Our Case Number: ABP-322166-25

Re: Proposed residential development for Corrib Causeway, Dyke Road
Corrib Causeway, Dyke Road, County Galway

Re Case No – ABP 322166-25.

Wastewater

Figure 5-82: D0050_01_RCZ_16 – Option 2

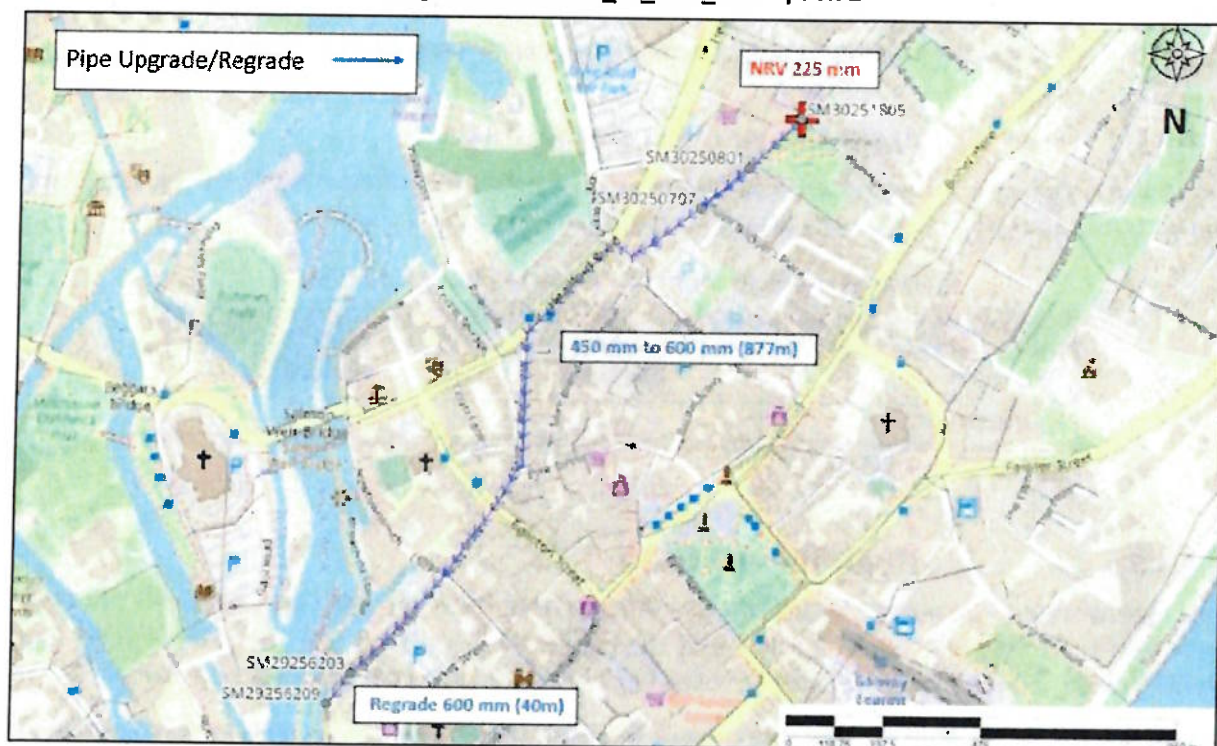
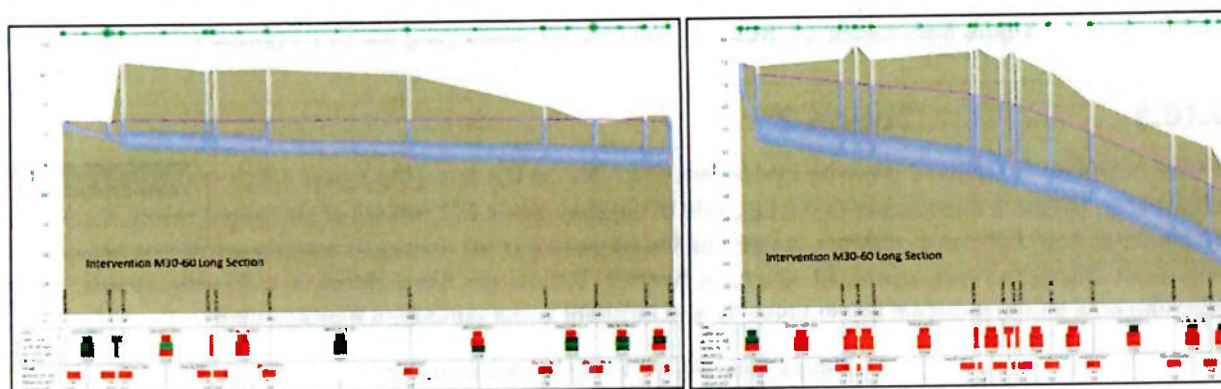
Two intervention options were assessed as part of the DAP Stage 4 report to alleviate the basement flooding issues. Option 2 was selected as the recommended option. Option 2:

- *“Involves the installation of a NRV [non-return valve] on the low-lying sewer” and*
- *encompasses the upgrade of approximately 877 meters of combined sewer, increasing the diameter from 450mm to 600mm, as well as the regrading of 40 meters of existing combined sewer (600mm) on St Bridget’s Place Lower, St Bridget’s Avenue, Wood quay, Mary Street and Bowling Green. These improvements aim to enhance sewer capacity and facilitate better surcharge management.”*

Replacing an existing 450mm diameter sewer with a new 600mm diameter sewer would increase the capacity of the sewer by 75% approximately.

The works proposed in Option 2 by Uisce Éireann are significant. If the proposed development is constructed and occupied before Uisce Éireann carries out the proposed works to the combined sewer the additional wastewater arising would exacerbate the flooding risks.

If this development was to proceed in advance of completion of the works recommended in Section 5.16 of the Galway DAP Stage 4 report it would exacerbate the flooding risk identified therein.

Figure 6-71: Long Walk SWO - Option 2 Foul/ Combined Upgrades (1)

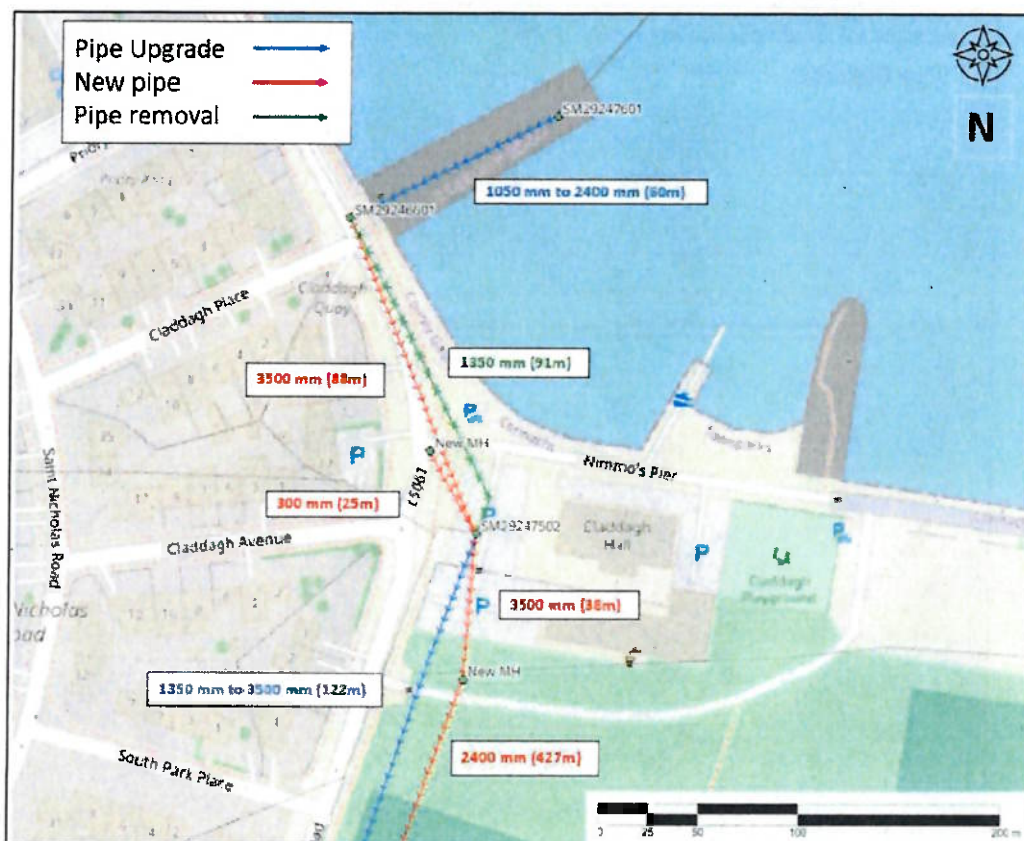
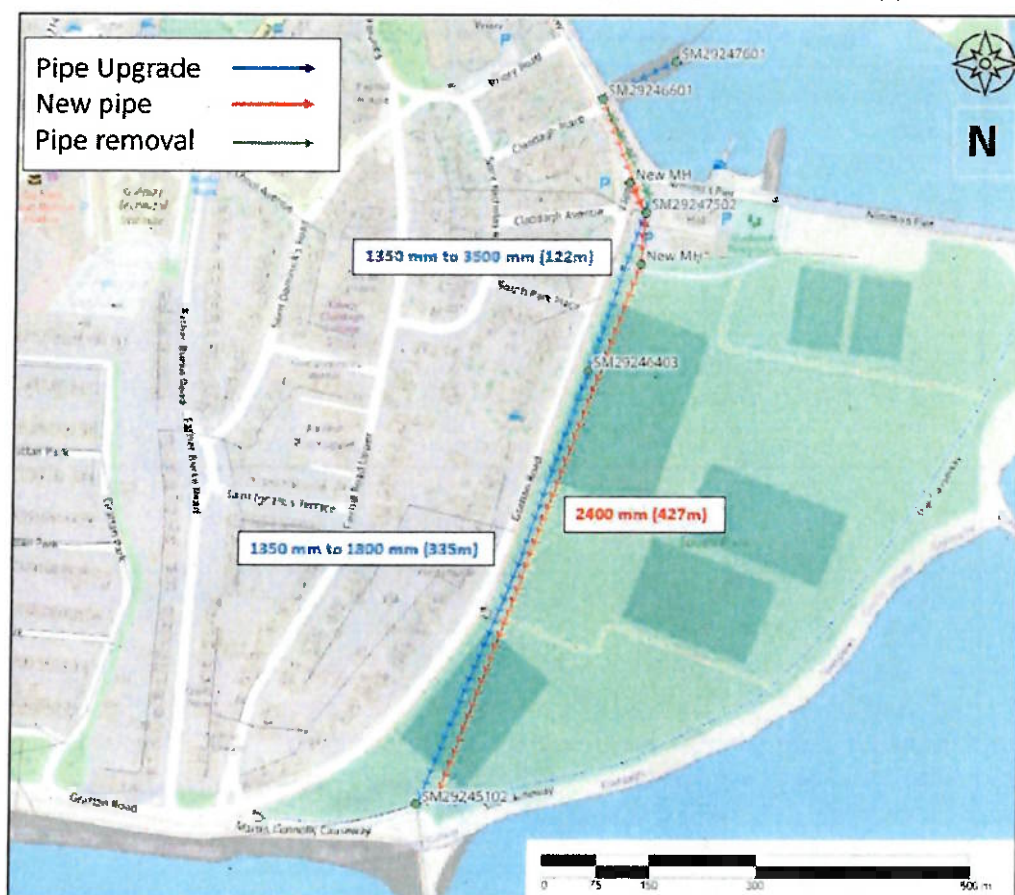
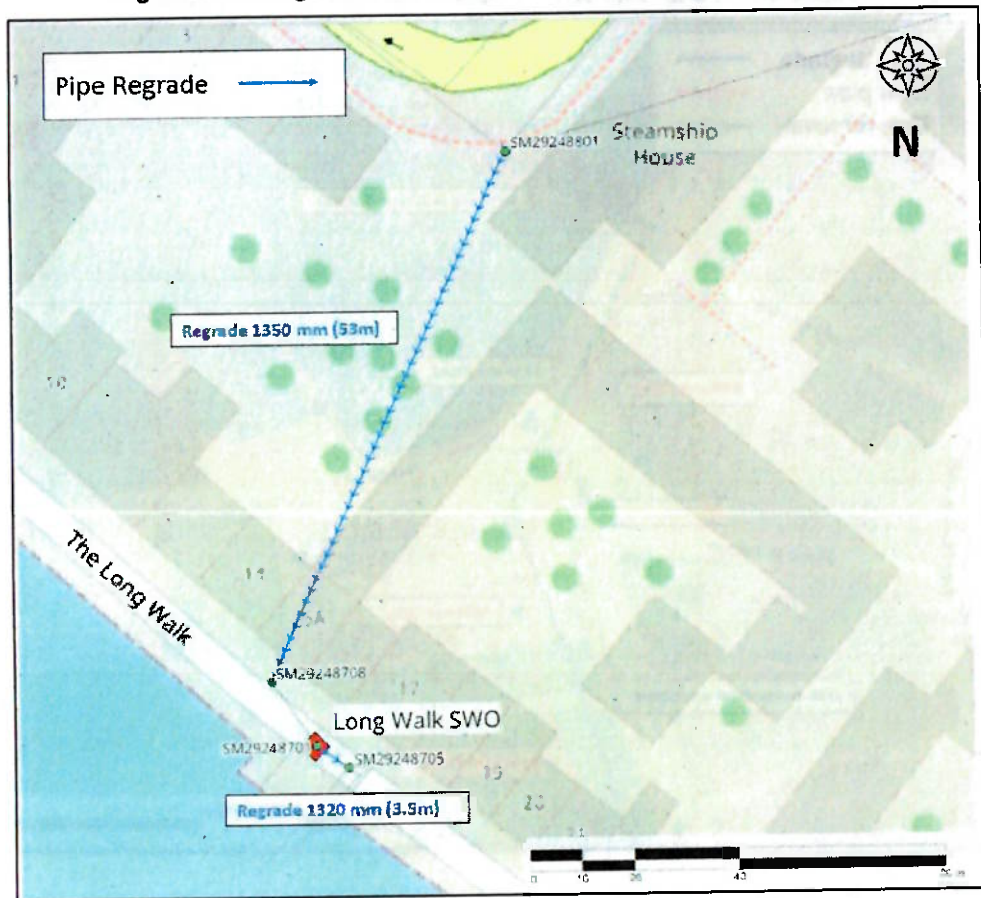
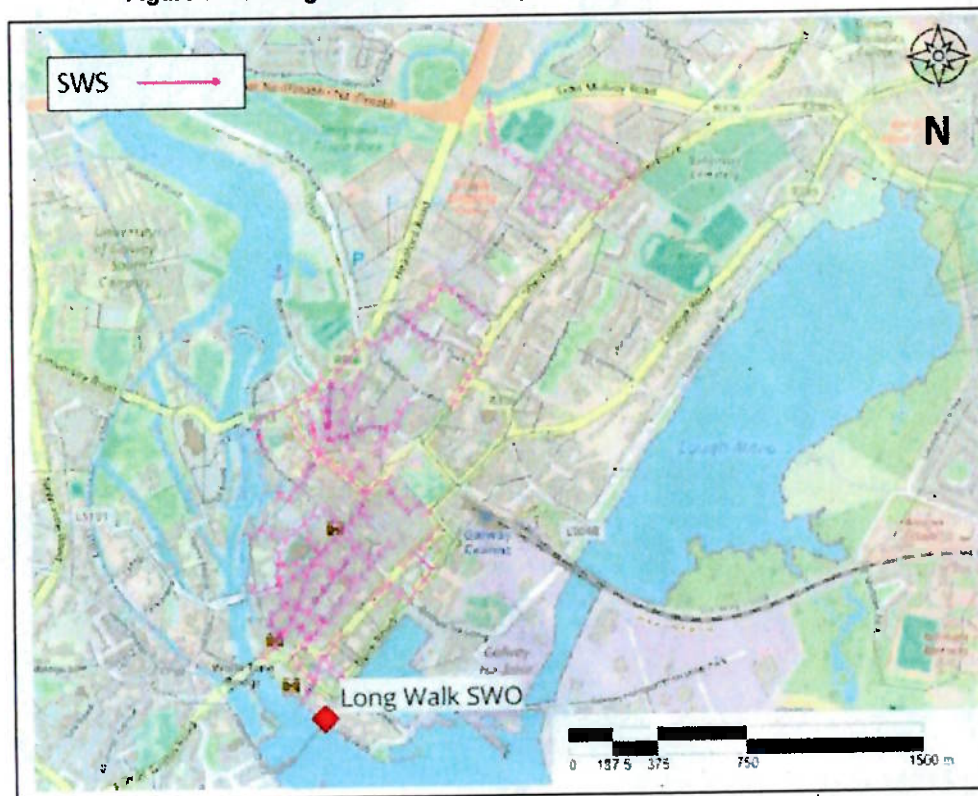
Option 2 is the recommended solution in the DAP Stage 4 report as *"Only Option 2 fully meets the risk reduction requirements for SWO spills"*. Option 2 includes the following extensive works:

- *The installation of approximately 6.8Km of surface water sewer (300/400/600/900mmØ) to facilitate separation of surface water from combined sewer upstream and reduce surcharge in the combined network, and*
- *Stormwater storage "in the form of online storage via combination of upgrading of the existing sewer network, provision of new twin/relief pipework downstream and oversized online storage pipework."*

It is noted in Table 9-11: Strategic Recommended Model Phasing of the DAP Stage 4 report that Option 2 will require *"some surface water separation work and the installation of new surface water sewers, requiring coordination and design collaboration with the Local Authority (i.e., the responsible authority)."* The collaboration of Galway City Council is required as the provision of storm water drainage is a matter for Galway City Council. There is no evidence that Galway City Council has agreed to take responsibility for the very significant stormwater drainage works included in Option 2. Representatives of Galway City Council attended 10 out of eleven Progress Meetings between 20 January 2023 and 16 November 2023, both dates inclusive. They were absent from Progress Meeting no. 42 on 21 September 2023 and Progress Meetings no. 45 to 56 from 17 January 2024 to 16 January 2025. However, it is recorded in the minutes of Progress Meeting no. 54 on 19 November 2024 that Conor Skehan, representing Galway City Council (but an employee of Uisce Éireann), *"has confirmed that he will be assuming the role of GCiC [Galway City Council] point of contact for this project, taking over from Pádraic Mac Giolla Bhríde"*. Pádraic Mac Giolla Bhríde had represented Galway City Council at seven meetings between 20 January 2023 and 16 November 2023, either on his own or with other colleagues. While Conor Skehan attended the final two further Progress Meetings, on 19 December 2024 and 16 January 2025, he was apparently representing Uisce Éireann, not Galway City Council, according to the minutes of those meetings.

An Taisce submits that An Coimisiún Pleanála should make the appropriate enquiries to establish to its satisfaction that Galway City Council has agreed to collaborate with Uisce Éireann in delivering the necessary extensive stormwater drainage works required as part of Option 2 in the Medium/Long Term. It should seek clarification as to when those works might be realistically be expected to be completed.

There is no evidence that Galway City Council has agreed to collaborate with Uisce Éireann in delivering the necessary extensive stormwater drainage works required as part of Option 2 to reduce the frequent overflows at the Long Walk SWO and achieve compliance with the Waste Water Discharge Licence.
